# Service Bulletin

**SUBJECT:** Service Update for Inventory and Customer Vehicles  
Driver Airbag Inspection - Expires with Base Warranty

**MODELS:** 2012 Chevrolet Cruze

2760232

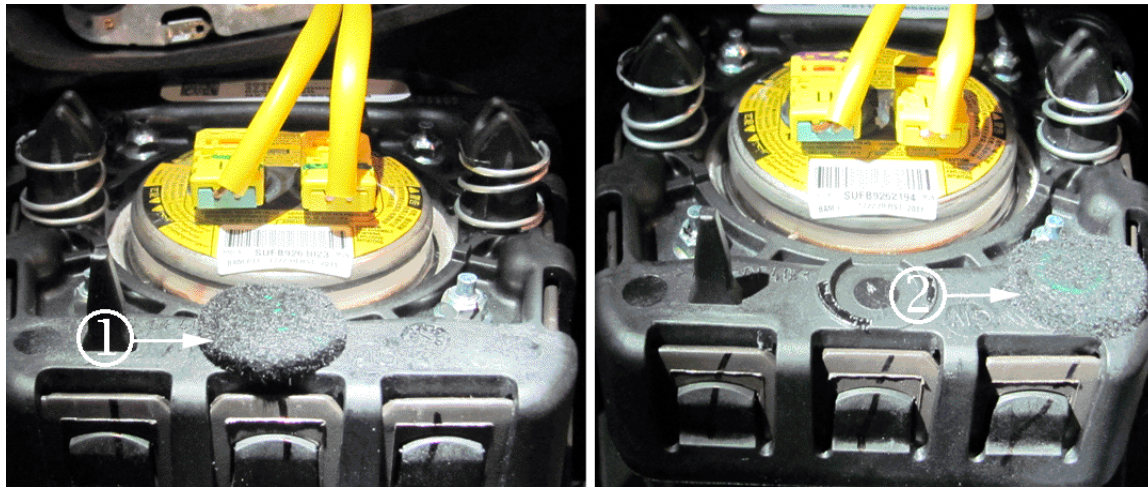
1. Determine if the steering wheel inflatable restraint module has been inspected and repaired. Turn the steering wheel 90 degrees to the right and look for a white dot (1) in the recessed pocket area on the back side of the steering wheel spoke.
  - If a white dot is NOT present, proceed to step 2.
  - If a white dot is present, no further action is required.
2. Disable the supplemental inflatable restraint (SIR) system. Refer to *SIR Disabling and Enabling* in SI.
3. Turn steering wheel 180 degrees to access the module release points on top of the column.
4. Insert suitable tools to the openings on both sides of the steering wheel.
5. Release the springs in direction of the arrows.

6. Remove the felt patch from the 6 o'clock position (1) and re-install it in the 5 o'clock position (2) as shown in illustration. The felt patch edge should be in line with the edge of the airbag module. The felt patch should not hang over the airbag module edge.
7. Align the steering wheel module fasteners to the steering column fastener holes.
